Architect's Supplemental Instructions

PROJECT: *(name and address)*
57-21113-00 - Rebid Dutchess Stadium
New Left Field Clubhouse, Seating Bowl,
& Restroom Building

ASI INFORMATION:
ASI Number: 004

Date: June 2, 2023

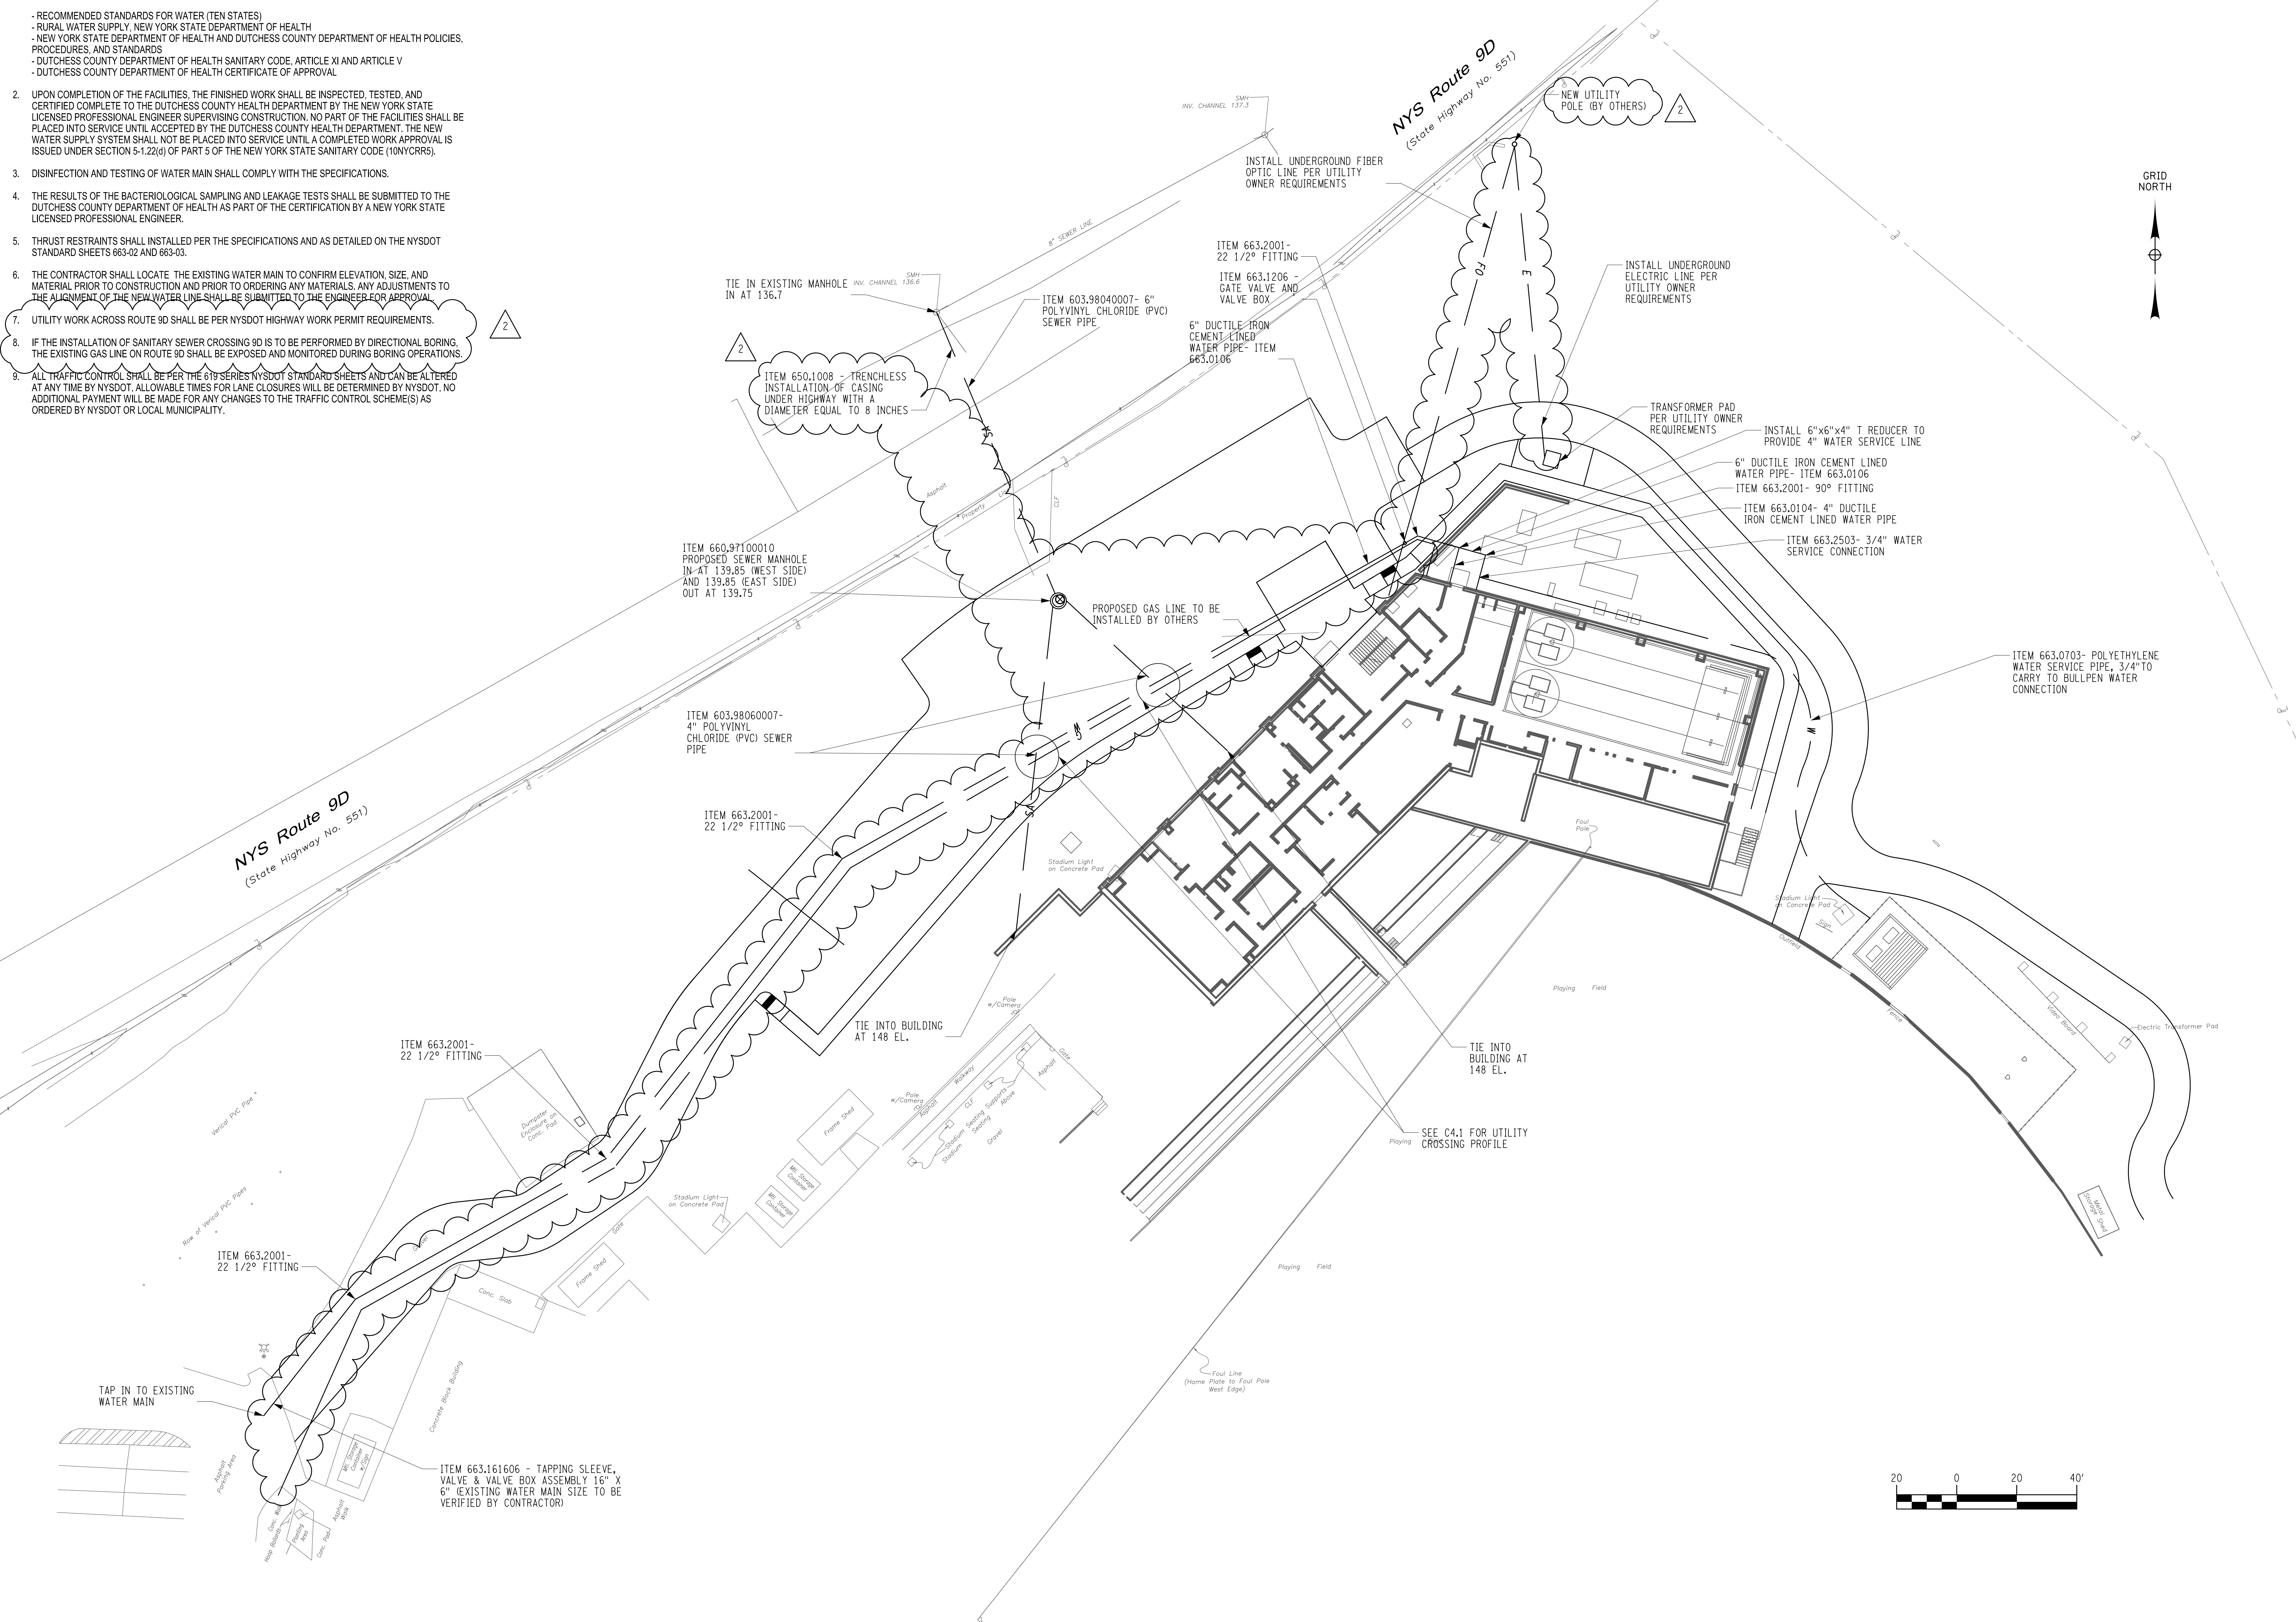
1. Sheet C4.1.ii – CIVIL UTILITY PLAN 1
 - a. Modifications per the attached sheet.
2. Sheet C5.1.ii – CIVIL DETAILS
 - a. Modifications per the attached sheet.
